# HISTORIC AND DESIGN REVIEW COMMISSION

**HDRC CASE NO:** 2023-384  
**ADDRESS:** 315 REFUGIO ST  
**LEGAL DESCRIPTION:** NCB 714 BLK 11 LOT S 67 FT OF 12  
**ZONING:** RM-4, H  
**CITY COUNCIL DIST.:** 1  
**DISTRICT:** Lavaca Historic District  
**APPLICANT:** David Hannan Jr/FISHER HECK ARCHITECTS  
**OWNER:** KNIGHT ROBERT WILLIAM & RAMON ALEJANDRO  
**TYPE OF WORK:** New construction of a 2-story addition  
**APPLICATION RECEIVED:** September 14, 2023  
**60-DAY REVIEW:** November 13, 2023  
**CASE MANAGER:** Rachel Rettaliata

1. Modify the fenestration on the primary structure.
2. Construct an approximately 764-square-foot, 2-story rear addition.

1 NEW ADDITION FOOTPRINT  
1/4" = 1'-0"

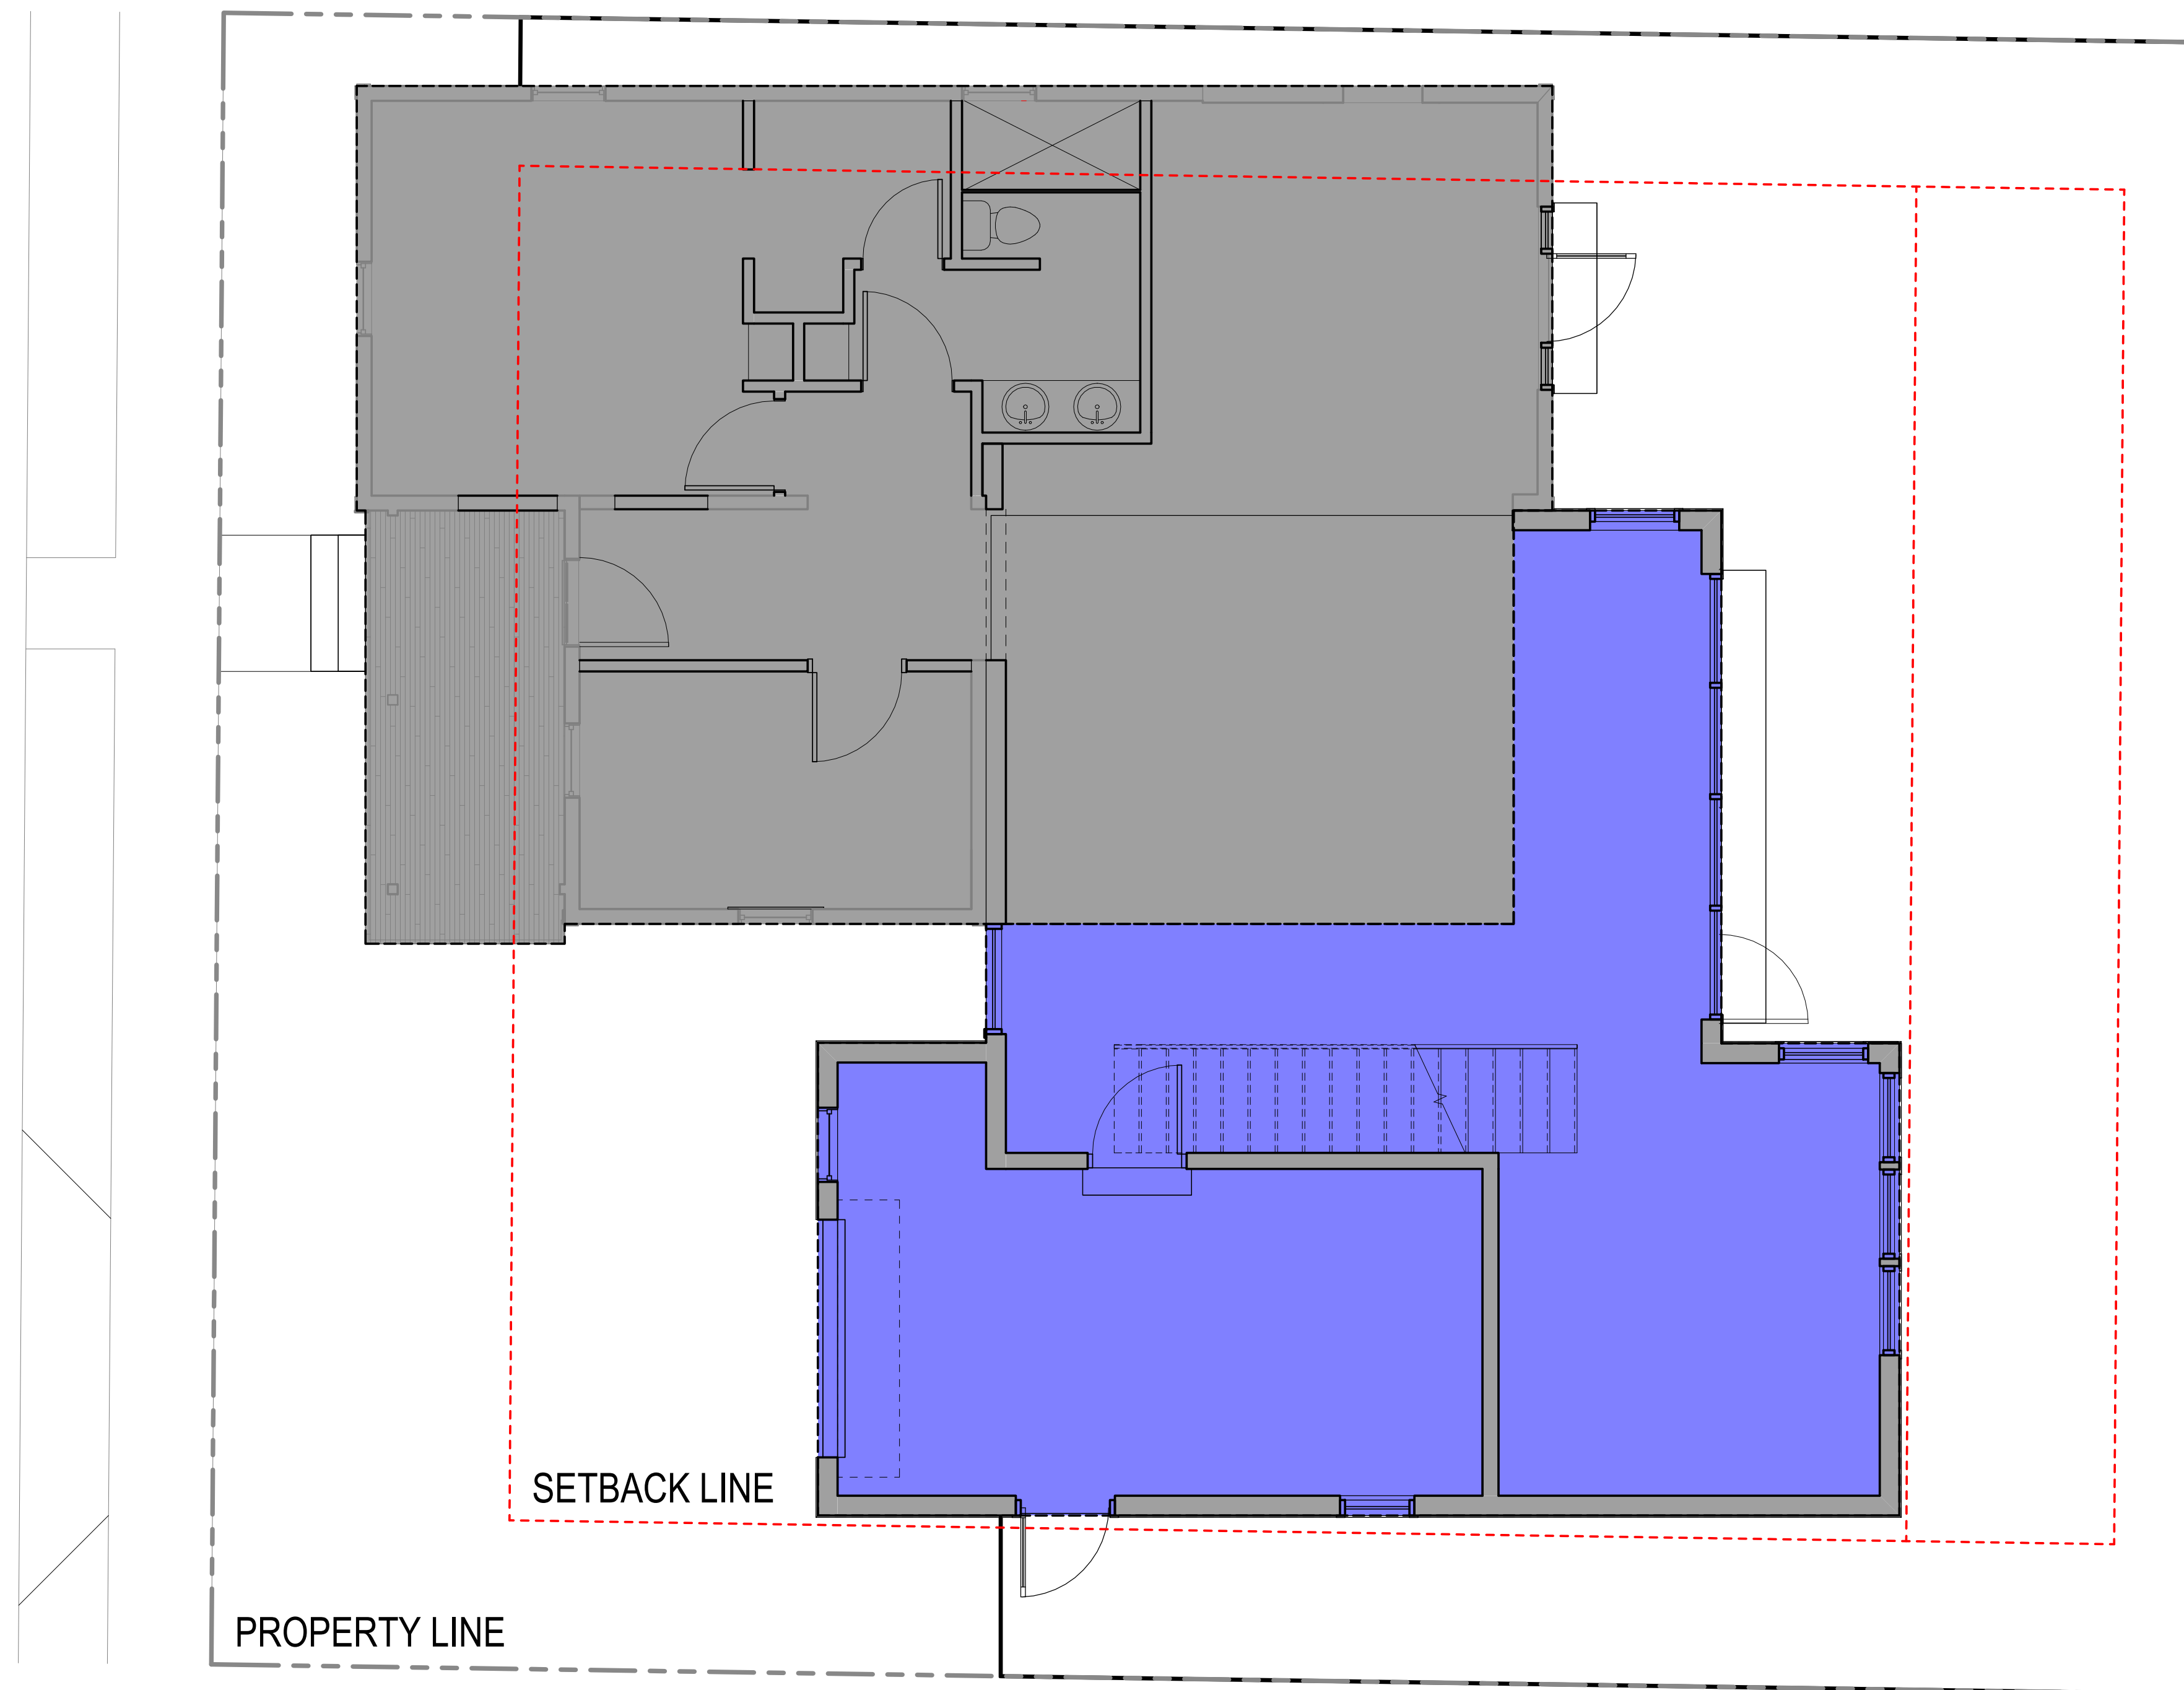
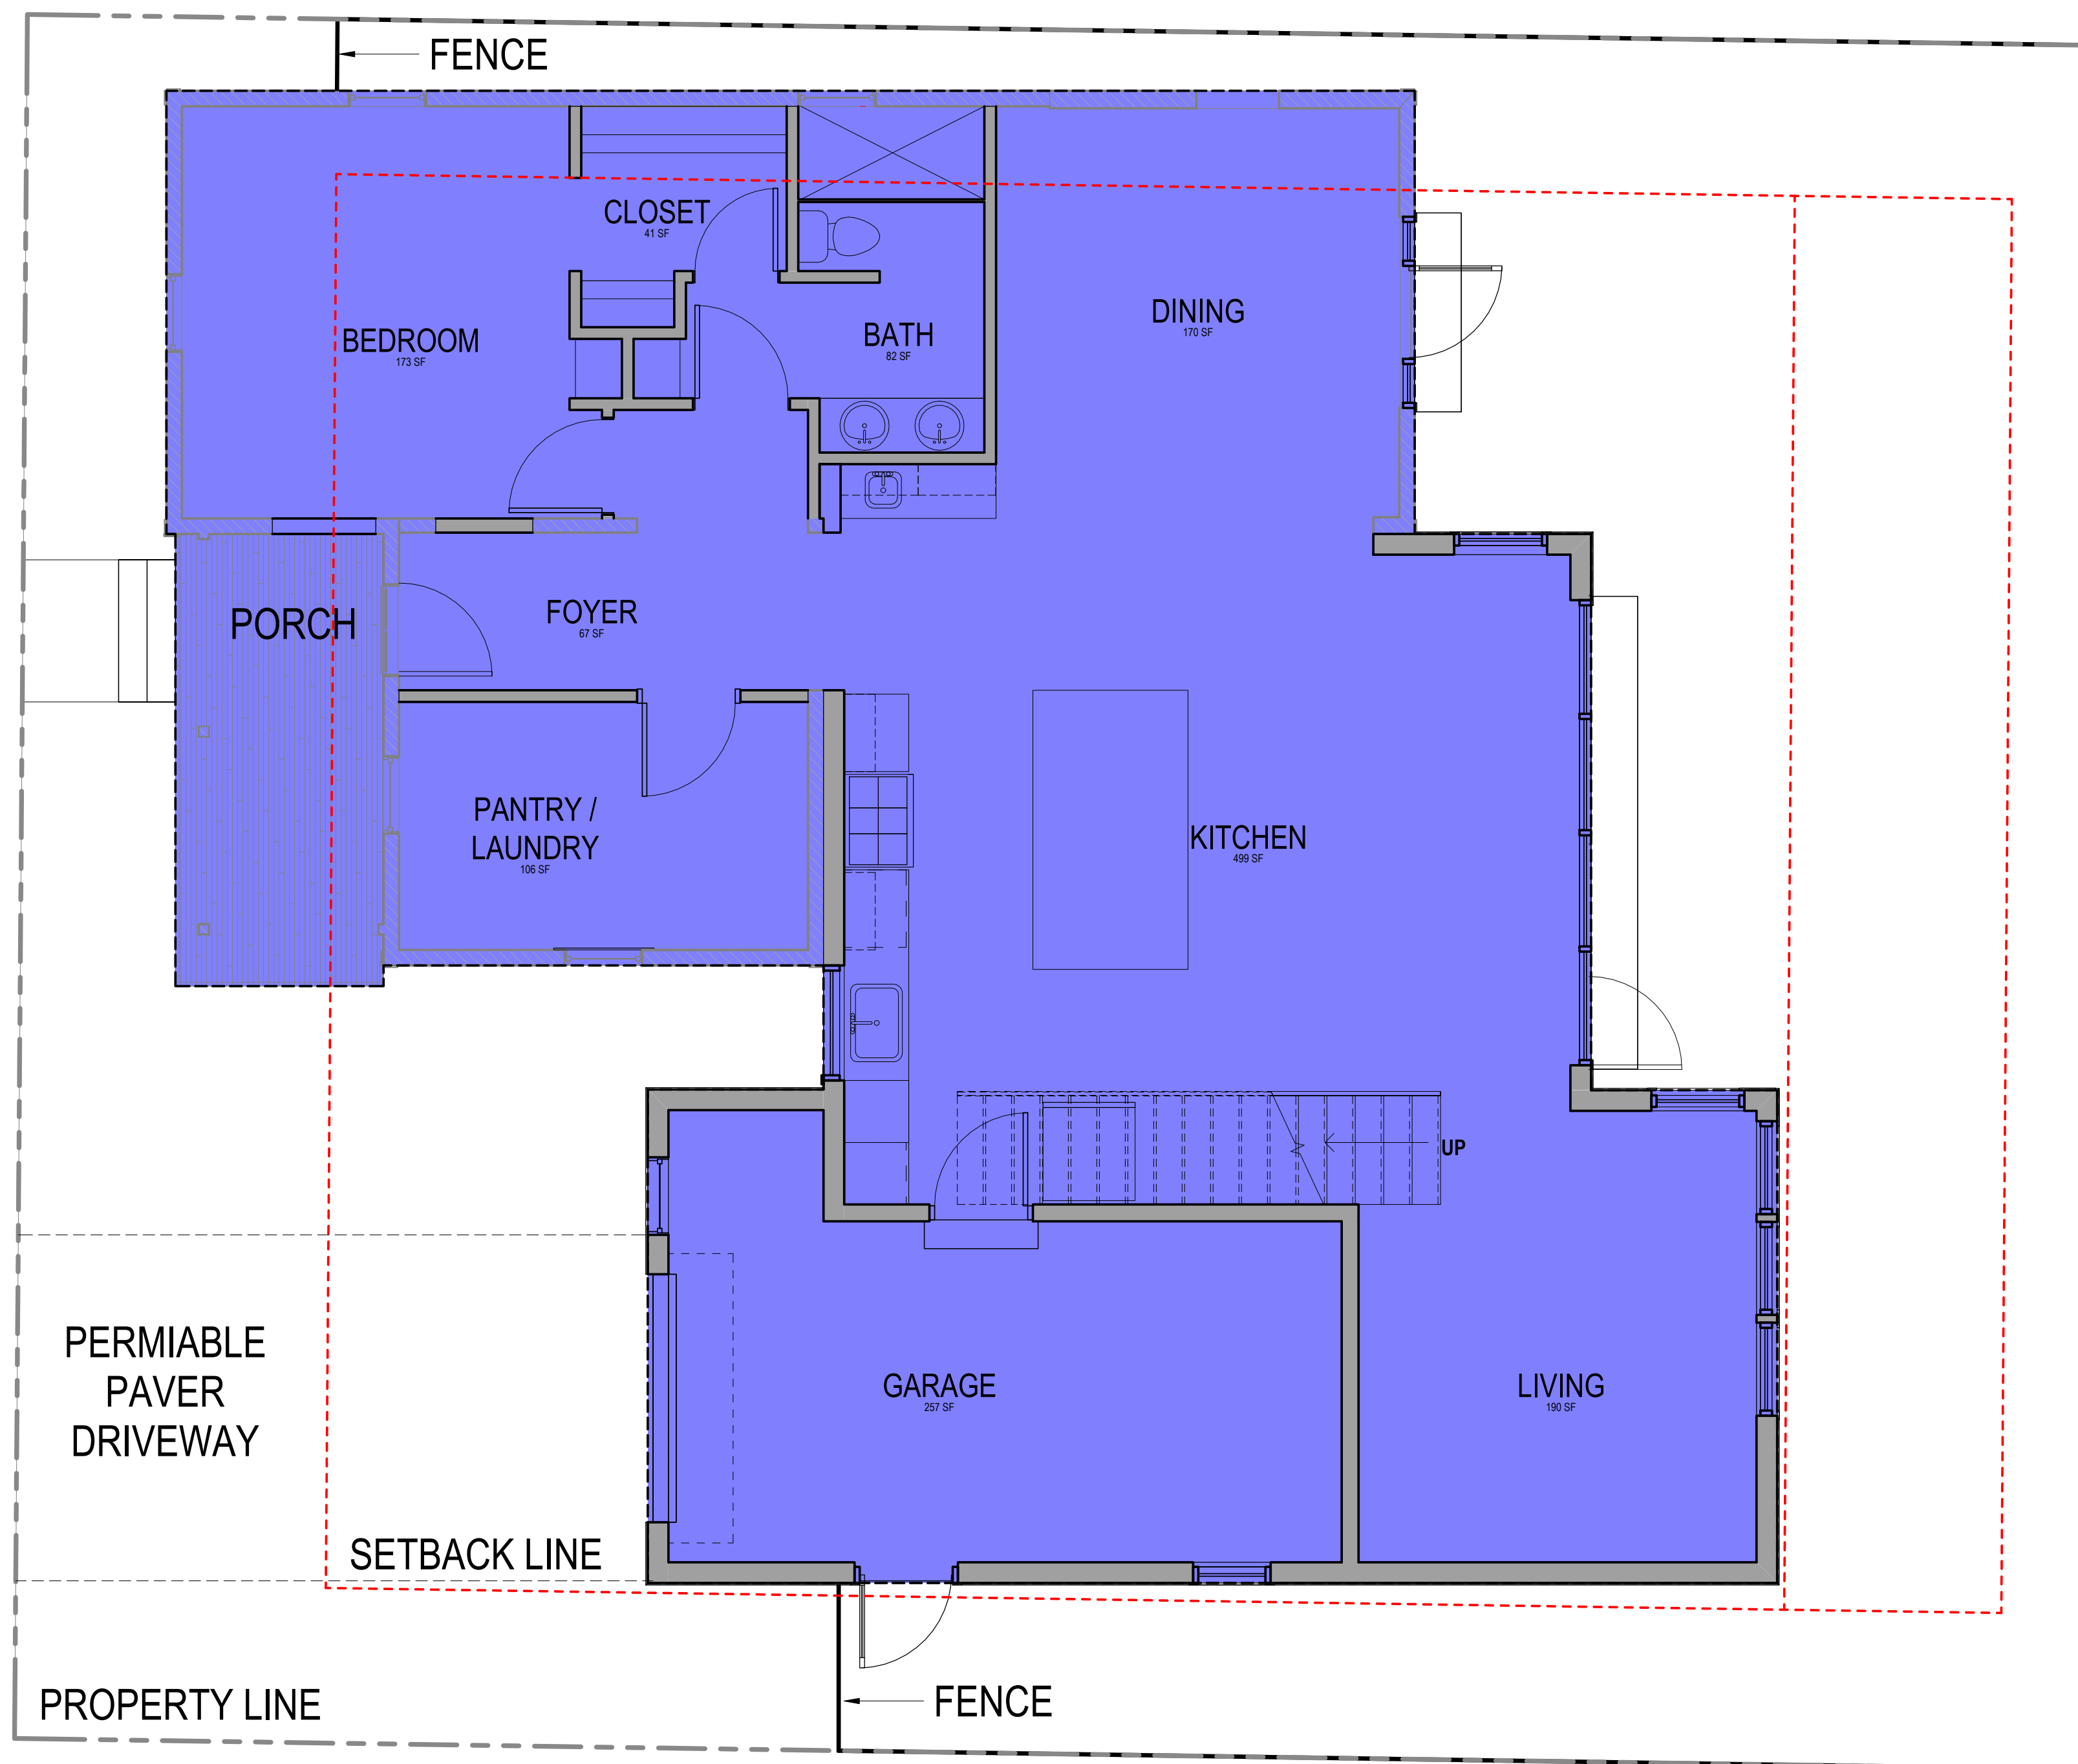
- i. That the applicant reduces the total lot coverage to less than 50 percent based on finding f and submits updated plans to staff for review prior to returning to the HDRC for conceptual approval.
